Location:
41 E. Main Street

Request:
Major Site Plan

Applicant:
Elizabeth Swearingen,
Peninsula Architects

Hudson Planning Commission	SITE PLAN REVIEW – VILLAGE DENTAL
Case No. 25-1022	October 13, 2025

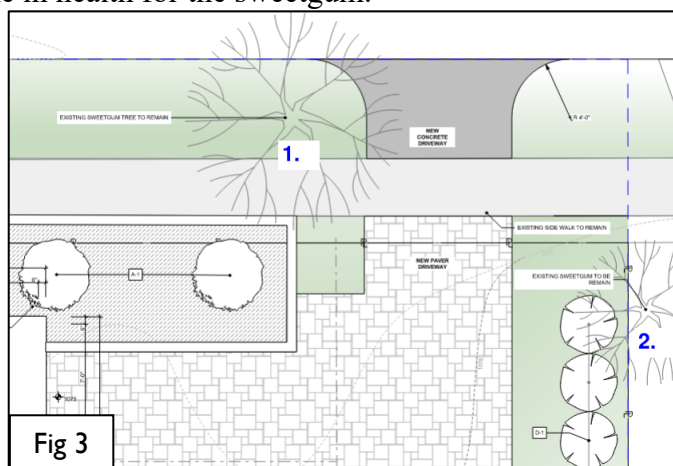
☐ **Limits of disturbance and Tree protection 1207.02**

Staff notes, overall, limited grading and tree removal is proposed; however, the City Arborist has reviewed the plans and notes the following:

1. If the proposed improvements are made to the site, the existing mature red oak located within the city right of way (identified as a Sweetgum Tree on the plans) would be compromised (Location marked as #1 in Figure 3 below). The tree measures 33" DBH and 36" diameter-at-base and is estimated to be 65 feet tall. The structural root zone (SRZ) is calculated to be 9' radius. No buttress roots within this SRZ shall be severed as it put the tree at risk of failure. Additionally, the tree protection zone (TPZ) would be, at minimum, 49-foot radius. Any cuts, fills, compaction, or otherwise damage to roots within this TPZ could compromise the tree's health and cause decline.

2. Additionally, there is a Sweetgum located on the adjacent parcel that could be affected by the proposed development (Location marked as #2 in Figure 3 below). The proposed area of disturbance falls within the TPZ but not the SRZ. Any damage to roots within the TPZ would potentially lead to a decline in health for the sweetgum.

Staff notes the proposed concrete drive apron is proposed directly adjacent to the mature street tree. Staff has previously recommended the applicant explore the feasibility of entering into a shared access agreement to utilize the neighboring drive to the east. Such would reduce the total number of adjacent curb cuts and potentially protect the mature street tree. Question if the applicant has explored this possibility. Additionally, the applicant should provide additional documentation/protection measures for the adjacent Sweetgum tree.

3. Provide additional documentation regarding protection measures for the existing Sweetgum tree identified in Figure 3 of this report.
4. Revise the landscaping drawings to incorporate evergreens along the eastern property line.

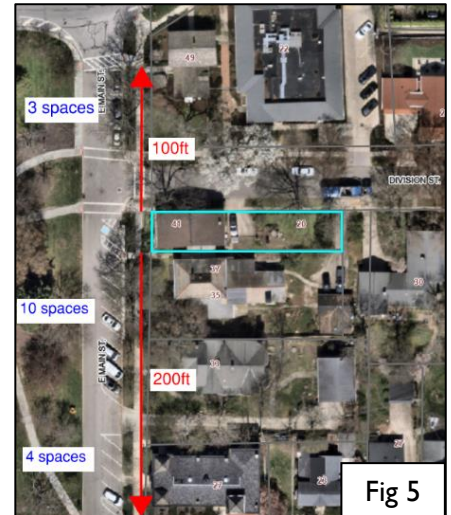
☐ **Landscaping**
1207.04

Staff notes existing landscaping would be removed along the eastern property line depicted in Figure 4 below. This landscaping would be replaced by 6 Korean Spice Viburnums. Staff recommends evergreens be planted in lieu or in addition to the viburnums to help buffer the adjacent residential homes to the east.
